Draft EIR Comment Letters

RE: DRAFT ENVIRONMENTAL IMPACT REPORT FOR 6000 HOLLYWOOD BOULEVARD DATED NOVEMBER 6, 2024 STATE CLEARINGHOUSE NUMBER: 2023050659

Figure 4: Receptors In Model

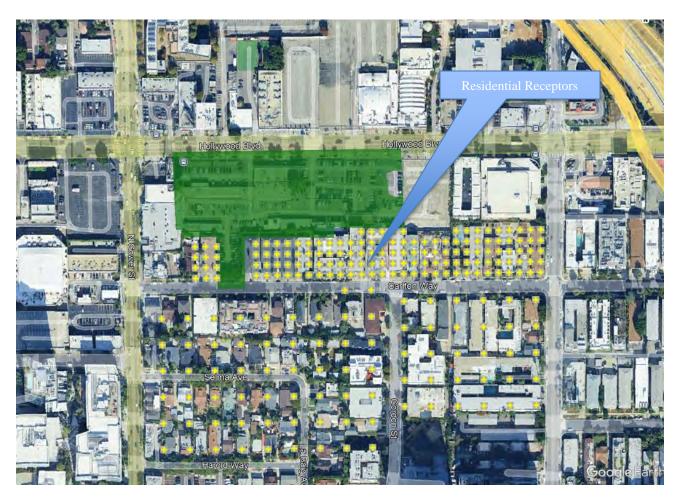
Using AERMOD, the US EPA's preferred air dispersion model, it is possible to calculate the concentrations of DPM from the construction area at the closest receptors near the construction site. AERMOD is an acronym for the American Meteorological Society/Environmental Protection Agency Regulatory Model Improvement Committee's Dispersion Model. AERMOD contains the necessary algorithms to model air concentrations from a wide range of emission source types, including stack-based point sources, fugitive area sources, and volume sources. The modeling domain with the building around the Project site are indicated in the figure below. The green area is the source area of DPM from construction of the Project.

Using the SCAQMD's AERMOD Health Risk Assessment Tool and AERMOD-Ready Meteorological Data Files website⁷ I have determined that the Project Site resides in the area designated by SCAQMD as SRA-1. The designated surface meteorological station for SRA-1 is KFUL. The data for the site cover the years 2018, 2019, 2020, 2022, and 2023.

Figure 6: Model output showing DPM concentrations During Construction Phase

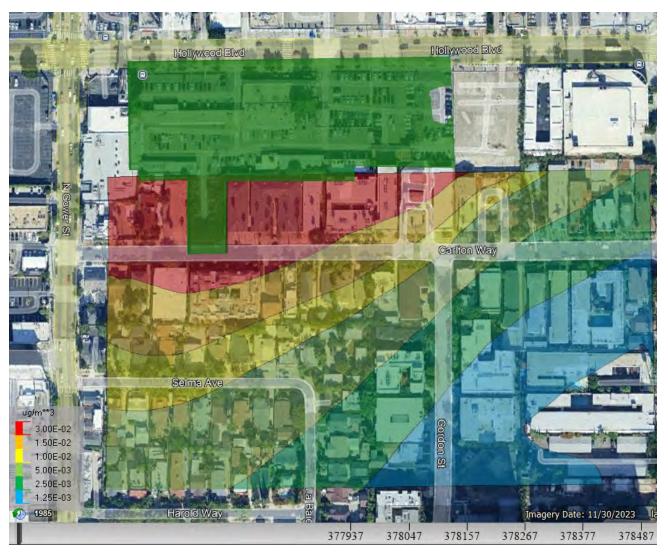
Using the algorithm outlined in OEHHA's HARP 2 Standalone Risk software, the cancer risk to the most sensitive population, infants less than 3 years old was calculated. To calculate the inhalation cancer risk for any receptor in the modeling domain dose of the chemical in air (Dose_{air}) is calculated from the annual concentration of the carcinogen (C_{air}). The exposure concentration is then multiplied by the breathing rate per body weight (BR/BW), inhalation absorption factor (A), the exposure frequency (days per 365 days) and a conversion factor of 10⁻⁶ (micrograms to milligrams, liters to cubic meters). This annual average concentration is multiplied by the cancer slope (CPF) for the chemical along with the appropriate age sensitivity factor (ASF) the exposure duration (ED) and then divided by the averaging time (AT)

Using the maximum concentration modeled, the cumulative risk for exposure of infants during the 3.67 years (44 months) of construction is 40.5 in 1,000,000, much greater than the 10 in 1,000,000 significance threshold outlined by SCAQMD, resulting in a significant impact. The results of the air model and the health risk analysis are attached as an appendix to this letter. The City must quantify and disclose these significant impacts in a REIR for the Project

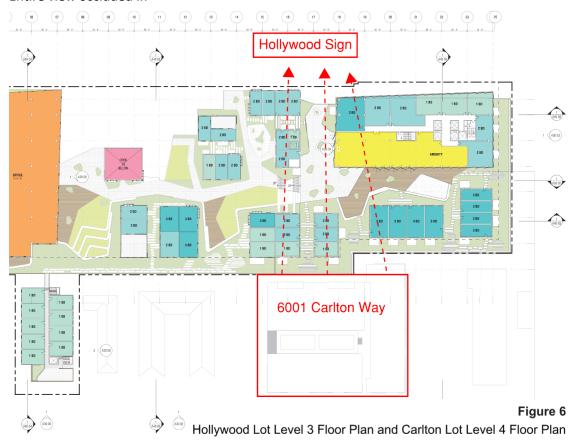
The light and glare was proposed as "insignificant" whereas the large glass faces will certainly cause severe glare on neighboring buildings and residents.

Blocking views of the Hollywood Sign would diminish the neighborhood's character and disproportionately affect long-term homeowners. I urge the City Planning Department to work with the developers on **design modifications that preserve this iconic view**, such as height reductions or alternative massing strategies, to better serve the community's needs.
